LITTLE TIDCOMBE FARM AND TIDCOMBE HALL

**Review of Landscape and Visual Impact Assessment relating to land at Tidcombe Hall and
Little Tidcombe Farmhouse, contingency housing allocation, and unallocated land**

Planning reference number 20/01174/MOUT

7 June 2021

View 5 Uplozman Road / Blundell's Road / Post Hill

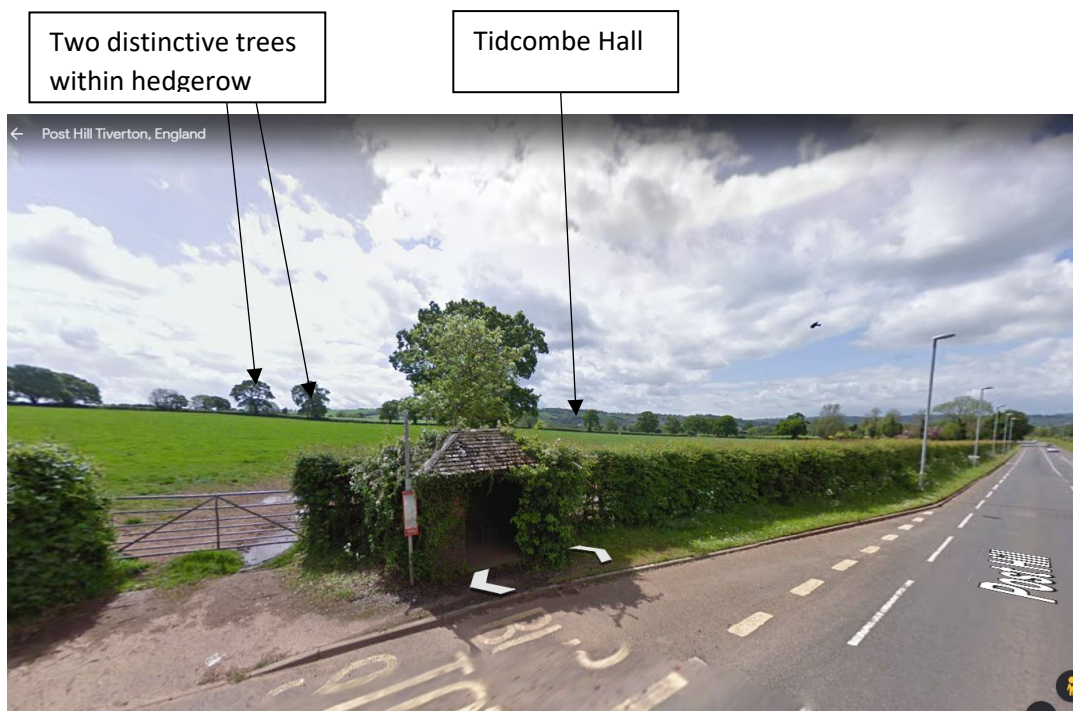
This view purports to be of the eastern urban extension but it is not. The field gateway is opposite the junction of Uplozman Road with Blundell's Road as it becomes Post Hill, and shows agricultural land that would remain as such. The eastern urban extension is behind the viewer further north and east. The location of the development site on the LVIA annotated photograph is also incorrect as the site is much further to the west, and Tidcombe Hall can just be discerned as shown on the marked up photo below.

The distinctive trees on the southern field boundary that match those in the LVIA photograph can be seen in this snip from Google Earth. While the below is not a photograph taken with the requisite methodology given in the GLVIA3, it illustrates that there is a view from this location, albeit it is unlikely to be significant (because of the distance from the site) and it is agreed that this impact would be minor.

View 8 Rowridge

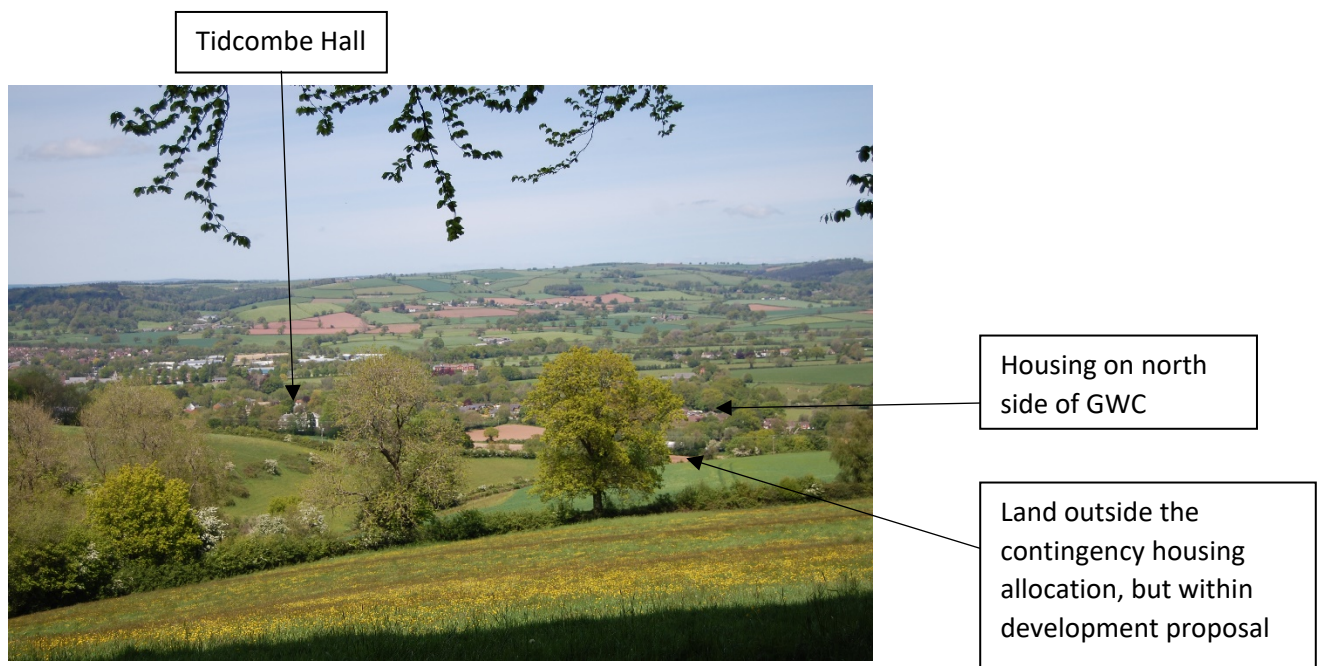
This location to the south east of the site is within the countryside and accessed via deep, narrow, Devon lanes. The north-south hedgerow boundaries, which are well vegetated with mature trees, make views of the site completely screened from this direction. It is agreed that there would be no impact from this location.
